ADDENDUM TO FINAL REPORT: RECOMMENDED TECHNICAL STANDARDS FOR GENERATOR LICENSING IN SOUTH AUSTRALIA

ADVICE TO ESCOSA

August 2017

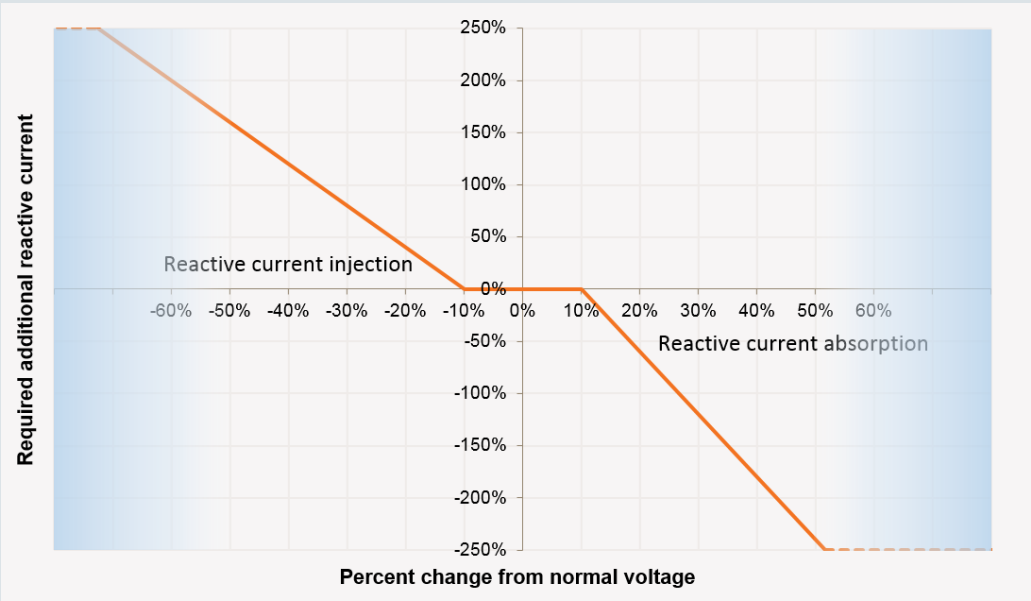
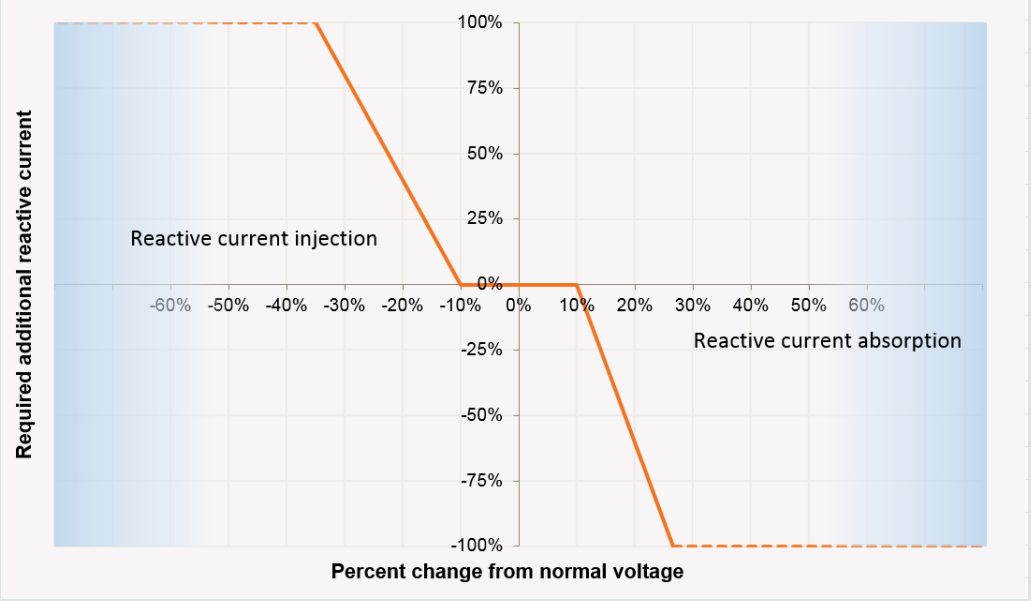
#	Report section	Focus area	Related NER Clause(s)	Summary of interim recommendations	Supporting notes (issues raised/justification of final recommendations)	Revised final recommendation to ESCOSA
						<ul style="list-style-type: none">• The reactive current response must be <i>adequately damped</i> as defined in the NER (Glossary, Chapter 10).• Reactive power consumption upon application of a fault must not exceed 5% of maximum continuous rated current of the generating system and limited to the duration of rise time.• The post-fault reactive power contribution of the generating system must be sufficient to ensure that the connection point voltage is within the following range for continuous uninterrupted operation:<ul style="list-style-type: none">– Voltages over 110% for the durations permitted under NER clause S5.1a.4;– 90% to 110% of normal voltage continuously;– 80% to 90% of normal voltage for a period of at least 10 seconds; and– 70% to 80% of normal voltage for a period of at least 2 seconds. <hr/> <p>Notes:</p> <ul style="list-style-type: none">• A graphical representation of these requirements is provided below in Figure 1 and Figure 2 for explanatory purposes.• It should be noted that the term '<i>settling time</i>' does not apply to synchronous machines in the context of fault current contribution because:<ul style="list-style-type: none">– <i>Settling time</i> as defined in S5.2.5.13 relates to the delay in a <i>control system</i> between a change in input signal and the associated change in output quantity.– Unlike non-synchronous plant, the fault current contribution of synchronous generators is provided through an intrinsic and uncontrolled response.– The fault current contribution of synchronous generators does not settle during the fault due to presence of large DC components in the fault current. This is unlike a power electronic controlled system such as a wind turbine or solar inverter where the DC component is practically eliminated.• Note that voltage disturbances in this condition are defined at the connection point, while performance characteristics are defined at the LV terminals the generating units and other relevant items of plant (including, but not limited to dynamic reactive power plant). Accordingly, the final reactive current injection/absorption limits at LV terminals will be determined by generating system component impedances behind the connection point - as indicated by the dotted lines in Figure 1 and Figure 2.

#	Report section	Focus area	Related NER Clause(s)	Summary of interim recommendations	Supporting notes (issues raised/justification of final recommendations)	Revised final recommendation to ESCOSA
						<p>Figure 1 Reactive current injection requirements for synchronous generators</p>  <p>Figure 2 Reactive current injection requirements for non-synchronous generating system</p>  <p>The generating system must be capable of restoring active power to at least 95% of the level existing just prior to a fault between 100 and 500 ms after disconnection of the faulted element, with recovery no slower than 500ms. The exact active power recovery time must be specified by ESCOSA.</p> <p>Transient active power consumption upon application of a fault must not exceed one power frequency cycle and must not exceed 5% of the maximum continuous rated current of the generating system.</p>
6	3.3.1	Disturbance ride-through – Active power injection requirements	S5.2.5.5(b)(2)	Require new entrant generators to be able to restore active power to at least 95% of the level existing just prior to the fault between 100 and 500 ms after disconnection of the faulted element. The exact	Refer to justification in AEMO's March 2017 advice to ESCOSA. Some stakeholders have requested clarification on the slowest level of active
